Subject: Response to December 26, 2002 "Request for Additional Information Regarding Severe Accident Mitigation Alternatives"
R. E. Ginna Nuclear Power Plant
Docket No. 50-244

**RESPONSE TO NRC'S REQUEST FOR ADDITIONAL INFORMATION REGARDING
[SEVERE ACCIDENT MITIGATION ALTERNATIVES (SAMAS)
FOR THE R. E. GINNA NUCLEAR POWER PLANT (GINNA)]**

Response to RAI 8a:**Spent Fuel Pool Cooling System Description**

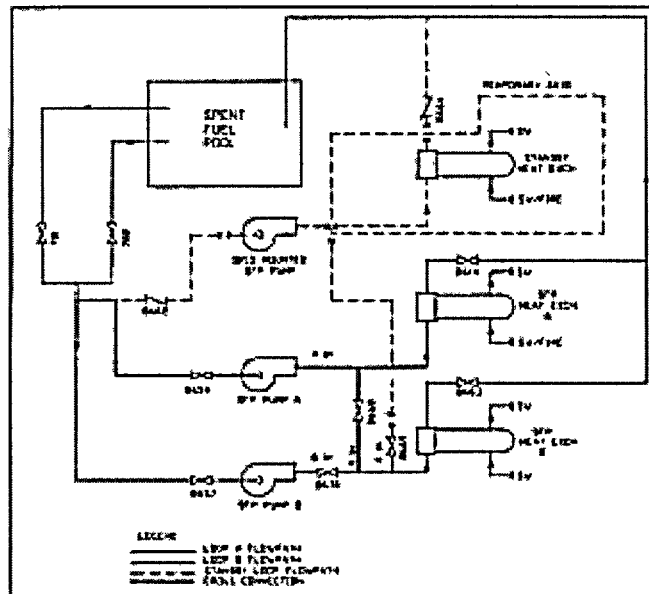
- a. Provide details on how spent fuel pool cooling is modeled in the PSA, the dominant accident sequences related to the loss of spent fuel pool cooling, and their contributions to CDF and dose consequences. Describe how spent fuel cooling accidents that contribute to CDF are treated in the Level 2 analysis.

The SFP cooling system functions to remove decay heat from irradiated fuel assemblies stored within the SFP. The amount of cooling required is dependent on the time since the fuel assembly was last irradiated and its burnup rate.

The SFP cooling system consists of three cooling loops. The primary loop (Loop 2) is made up of SFP pump B, SFP heat exchangers B, and piping. The backup loops include installed Loop 1 (SFP pump A, SFP heat exchanger A and piping) and skid-mounted Loop 3 (skid-mounted SFP pump, SFP standby heat exchanger, and hoses). These two backup loops also have the capability to cross-connect with the primary loop's heat exchanger.

Loop 1 and Loop 3 are each designed to remove the normal basis heat load with a pool temperature of 150°F and SW at 85°F. They are each capable of removing the normal basis heat load and when operated in parallel are capable of removing the safety basis heat load. This is also true if they both use the Loop 2 heat exchanger.

Each of the three loops consists of a horizontal centrifugal stainless steel pump and a shell and U-tube type heat exchanger. Service water is circulated through the shell while SFP water is circulated through the tubes. Loop 2 is supplied with SW from SW loop B. Loops 1 and 3 are supplied with SW from SW loop A. Motor-operated valves provide automatic and remote manual isolation of the SW supply to the heat exchangers associated with SFP cooling Loops 1 and 2 and the component cooling water heat exchangers. These valves close automatically upon coincidence of safety injection and loss of offsite power. Handwheels are provided for manual operation. The SFP Cooling System is shown in the following figure.

Figure 1
Loss of RHR Cooling Event Tree

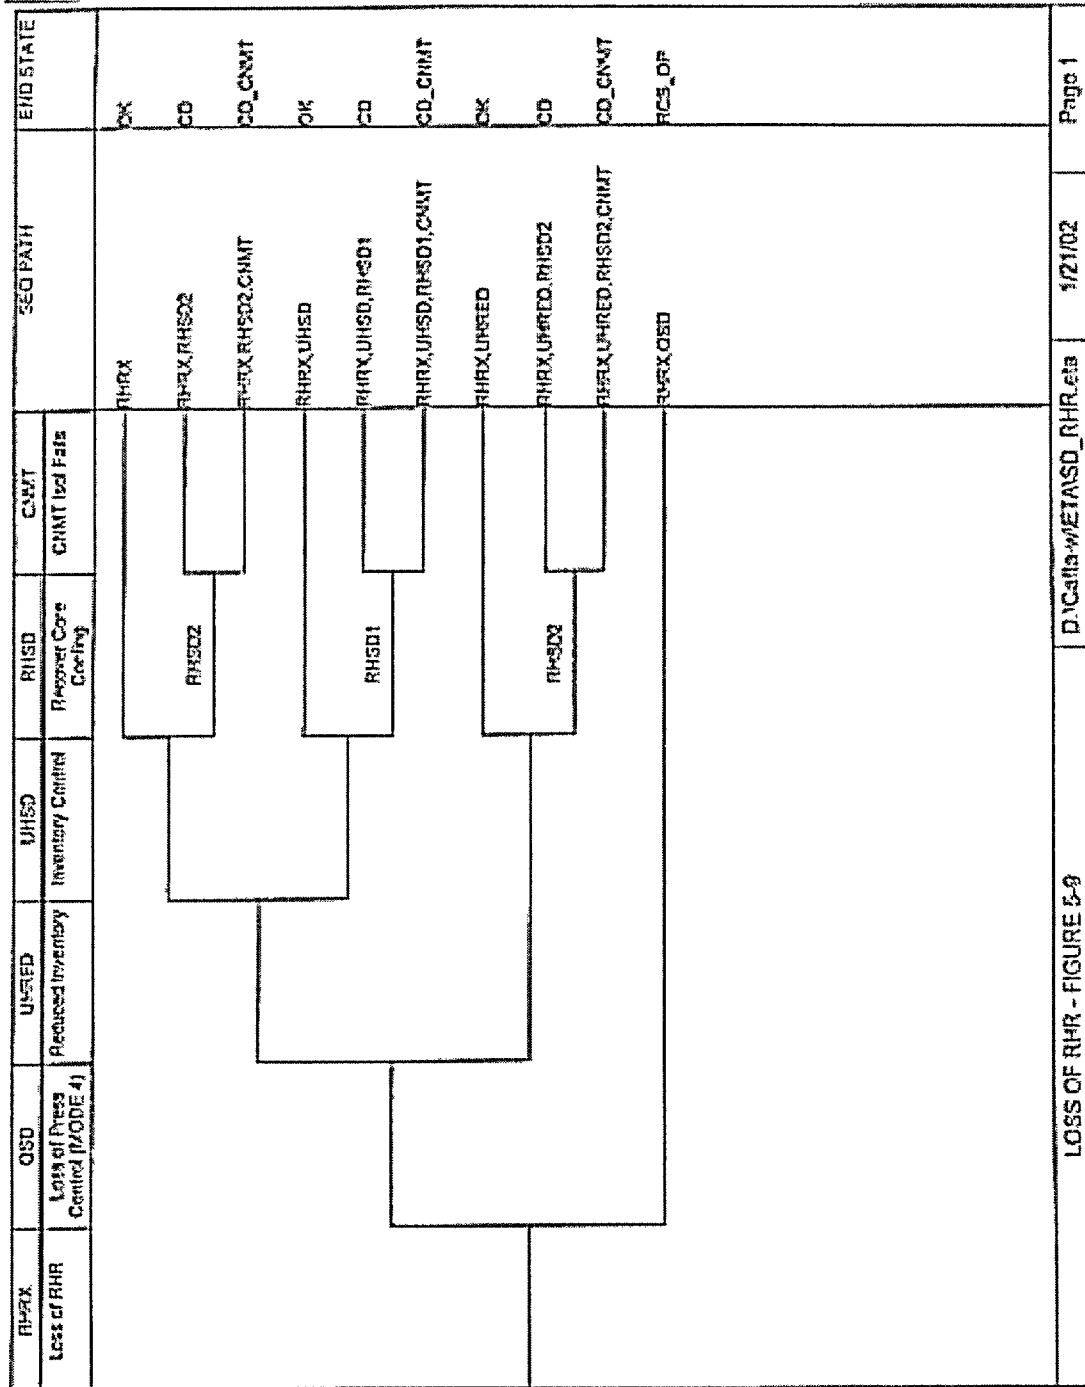
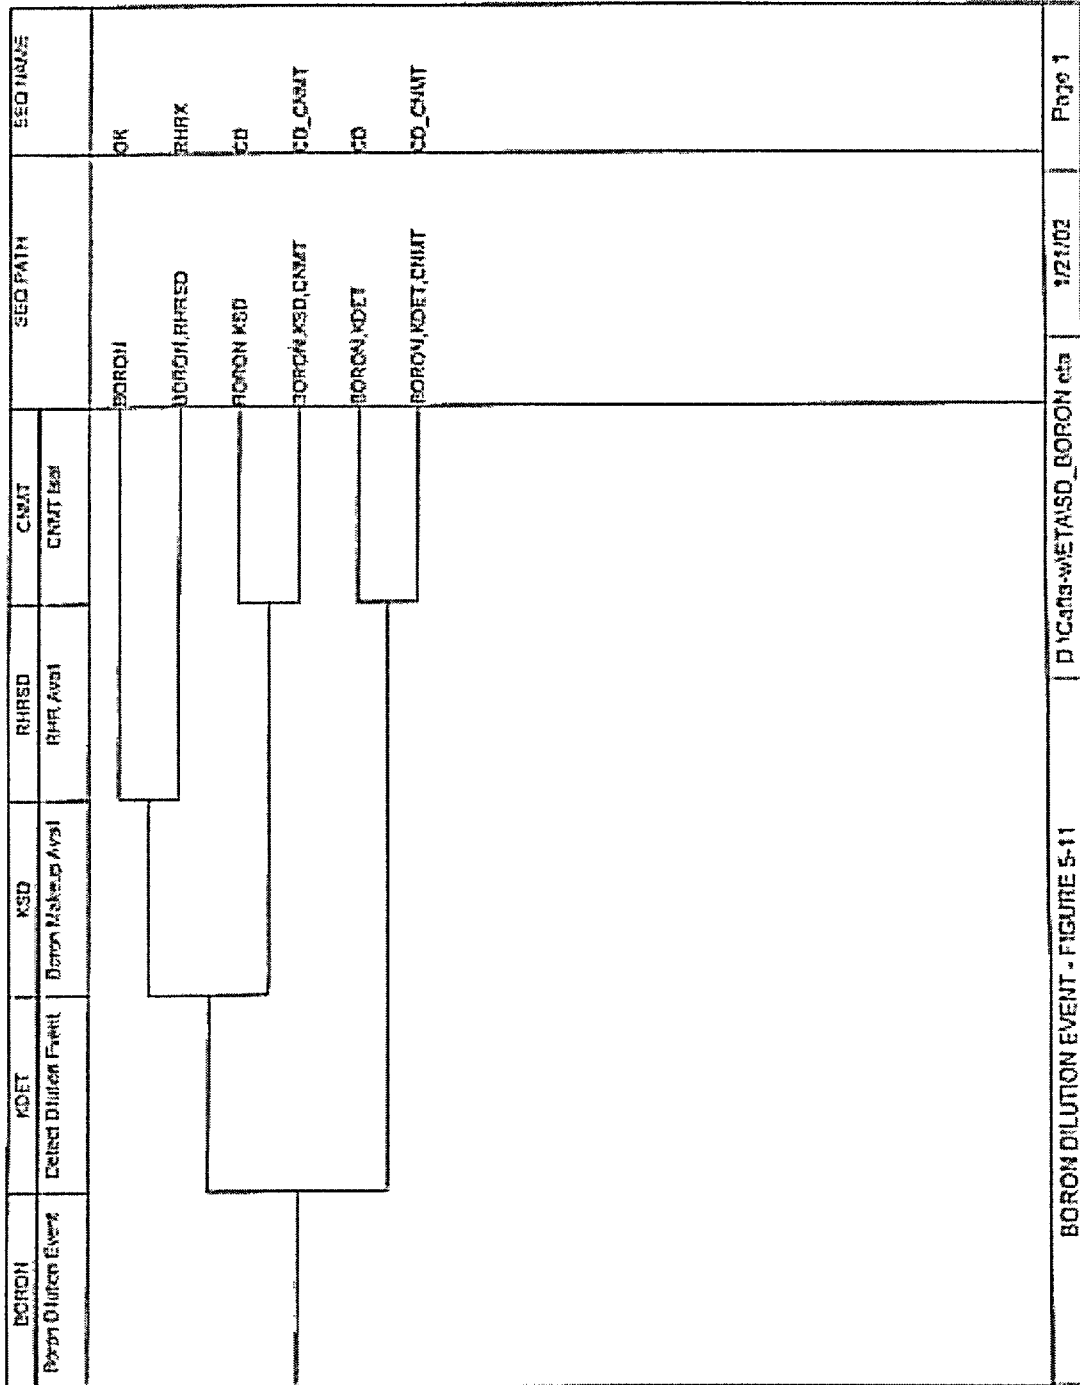
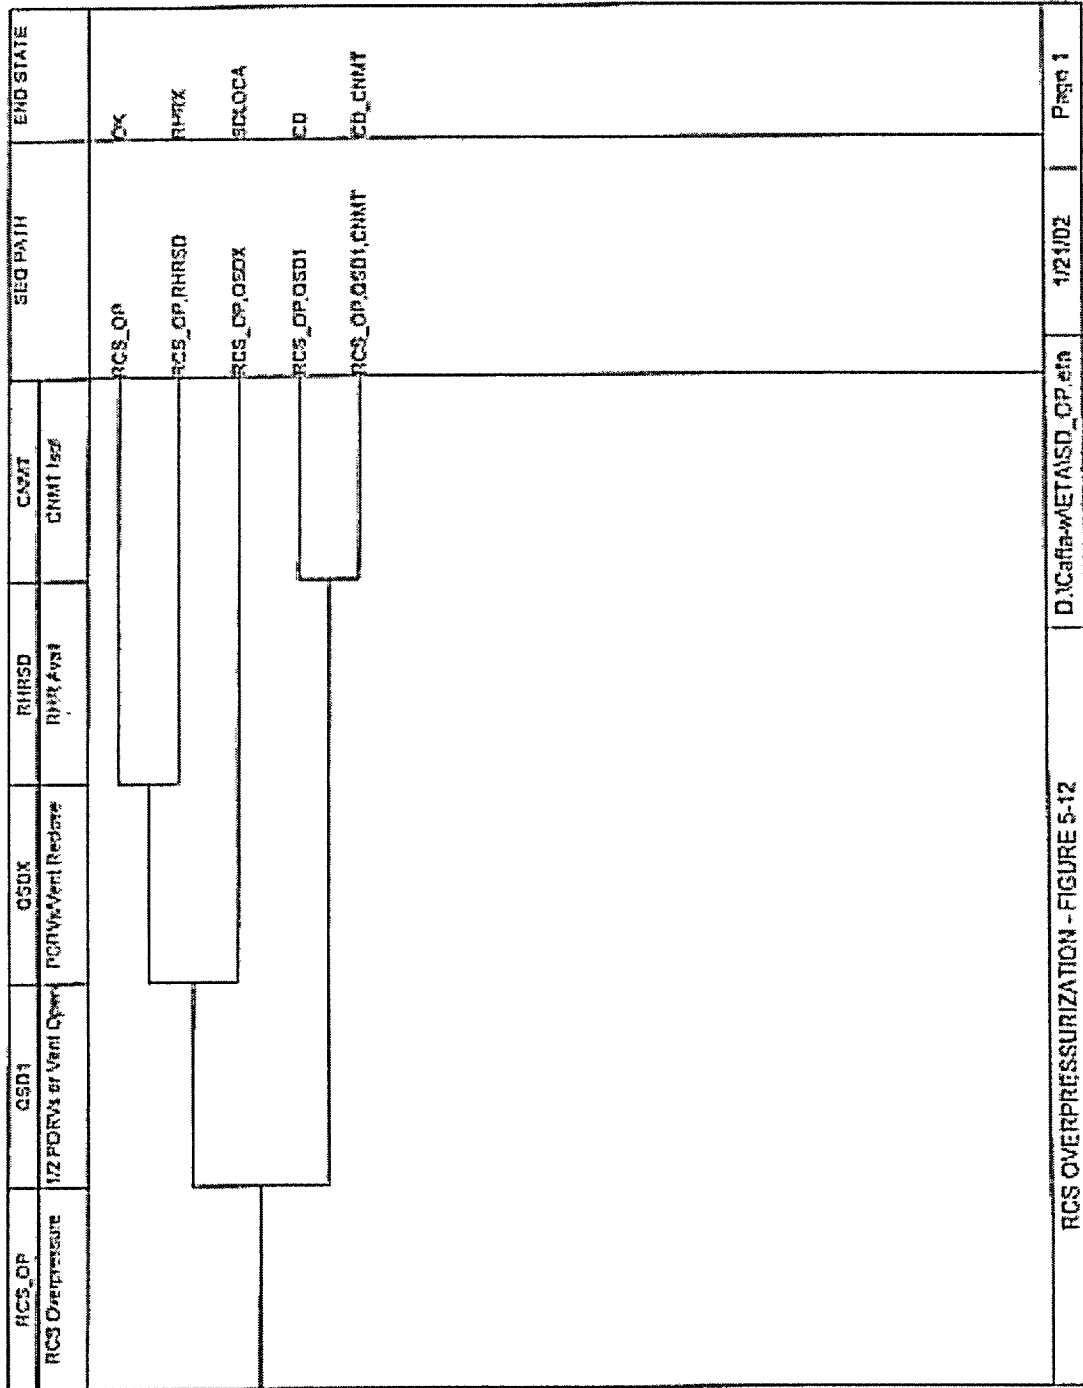
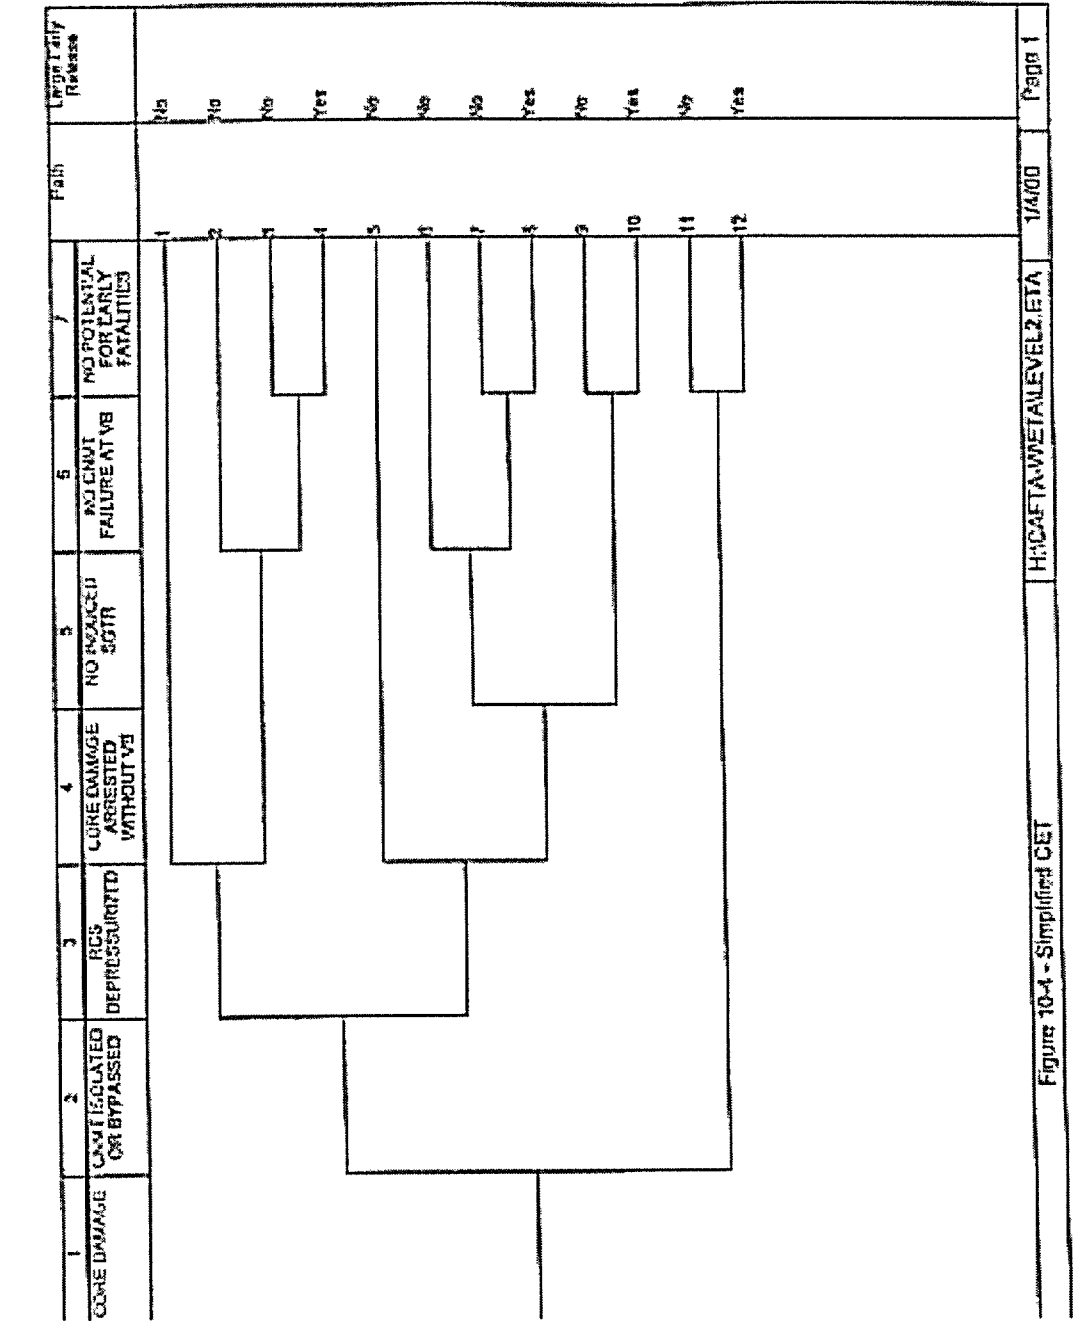
- c. Provide details on how shutdown operation is modeled in the PSA, the dominant accident sequences during shutdown, and their contributions to CDF and dose consequences. Describe how shutdown operation accidents that contribute to CDF are treated in the Level 2 analysis.

Note that only those shutdown events that can lead to CDF are discussed in this response; see response to RAI 8a for discussion on those leading only to a late release.

The at-power Level 1 analysis defined an initiating event as an "upset condition which results in either a manual or automatic reactor trip." Since the reactor is already tripped when the plant is shutdown, this definition is not applicable for the purposes of an evaluation with respect to shutdown events. Therefore, a new definition must be developed with respect to shutdown event initiators.

Loss of Residual Heat Removal (RHR) – The definition of a shutdown event initiator is one which occurs when RCS temperature is less than or equal to 350°F and results in either the loss of decay heat removal capability or a criticality event. Since RHR will be assumed to be in service when RCS temperature is less than or equal to 350°F in order to provide decay heat removal capability, its loss must be considered as a shutdown event initiator.

There are many potential configurations of the RHR System when shutdown, including operation of one, two, or no trains (i.e., defueled conditions). Consequently, the failure of support systems will have various effects on the ability of RHR to remove decay heat. The failure of Service Water, Component Cooling Water, Instrument Air, and electrical power must therefore be considered with respect to the status of the RHR System and cannot be considered as their own separate initiators. As such, support systems are not considered as their own shutdown event initiators, but will be addressed in the development of other initiator frequencies (e.g., loss of RHR, loss of SFP cooling). The loss of RHR initiator class is identified by TX000RHR.

Boron Dilution Event – Immediately following a plant trip or shutdown, the reactor is maintained subcritical by insertion of the control rods. However, reactor poisons that have built in over the course of power operation begin to decay, adding positive reactivity. This is compensated for by the use of chemical poisons (boron) to ensure that the reactor remains subcritical. The loss of this added boron has the potential to result in a criticality event depending on the fuel geometry within the reactor vessel and water level (the mass of water within the SFP is considered sufficiently large to prevent a boron dilution event). This initiator class is identified as TX0BORON.
